Re: Comments by Sun Microsystems, Inc. on the Draft 4 Energy Star Specification for Computer Servers

COMMENTS BY SUN MICROSYSTEMS, INC. ON THE EPA ENERGY STAR (DRAFT 4) PROGRAM REQUIREMENTS FOR COMPUTER SERVERS

Illustration 1: multi-core innovation to increase energy efficiency

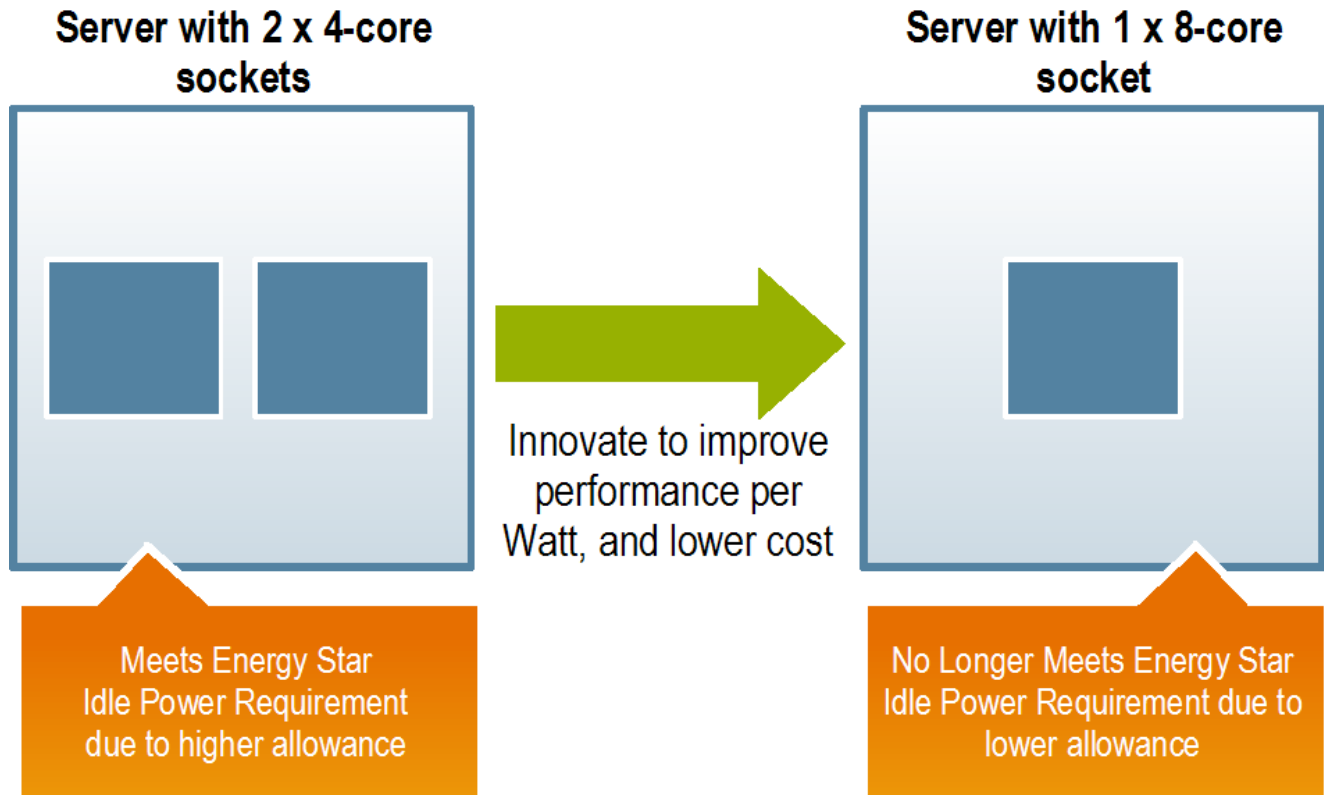
Recent vendor innovation in multi-core systems has decreased the overall energy consumption in the data center, and ought to be rewarded, not penalized. Multiple cores on fewer chips have been shown to increase efficiencies enormously. A 1 socket 8 core system does just as much work as a 2 socket 4 core system, but consumes significantly less power. As such, a 1 socket 8 core system can be used to replace a 2 socket 4 core system, thereby saving power overall in the data center. Hence, a vendor providing a 1-socket 8 core system ought to be rewarded, not penalized, for doing 8 cores worth of work with only 1 socket, as opposed to other vendors who do 8 cores worth of work with 2 sockets, thereby adding electrical overhead in the system design.

The current EPA specification penalizes, not rewards, systems with 1 socket and 8 cores by granting them a lower idle power allowance than systems with 2 sockets and 4 cores each.

- **Option 1:** *For systems with 8 core micro-processors, create a separate category (“Categories E and F”) for idle power allowances*
- **Option 2:** *Provide an adder for every core > 4 (20W/core)*
- **Option 3:** *Treat systems with 8 core innovation the same as 4 socket systems:*
 - *Exempt from any specific idle power requirement in Tier 1*
 - *Wait for an industry category to emerge after other vendors start shipping, and impose an idle power requirement in Tier 2*
 - *In Tier 1, permit systems to qualify for Energy Star if they meet all the other requirements*
